APPLICATION NO.	FILING DATE	FIRST NAMED INVENTOR	ATTORNEY DOCKET NO.	CONFIRMATION NO.
10/790,102	03/02/2004	Ming-Feng Wu	MR957-1466	1209
4586	7590	10/27/2005		
ROSENBERG, KLEIN & LEE 3458 ELLICOTT CENTER DRIVE-SUITE 101 ELLICOTT CITY, MD 21043			EXAMINER MAGUIRE, LINDSAY MONICA	
			ART UNIT	PAPER NUMBER
			3634

DETAILED ACTION

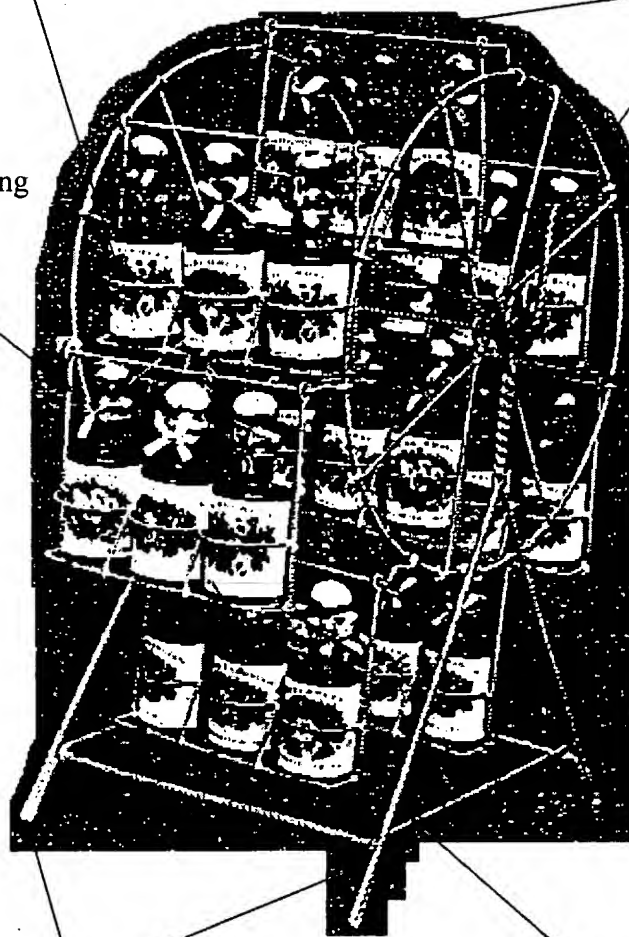
Spencer discloses a rack for holding objects on, comprising a main frame (4) having lateral supporting portions (3) at two ends; two rotary frames (2) pivoted to respective ones of the lateral supporting portions of the main frame; and a plurality of holding rack parts (5) each pivoted to the rotary frames at two ends thereof; each of the holding rack parts having a plurality of receiving holes (1) thereon for objects to be passed through (see attached sheet for Figure & reference numbers). In addition, Spencer also discloses that each holding rack has a plurality of rings connected together (5 and 1) for providing the receiving holes.

Receiving Holes (1)

Rotary Frames (2)

Holding
Rack
(5)

Lateral Supports
(3)

Main Frame
(4)
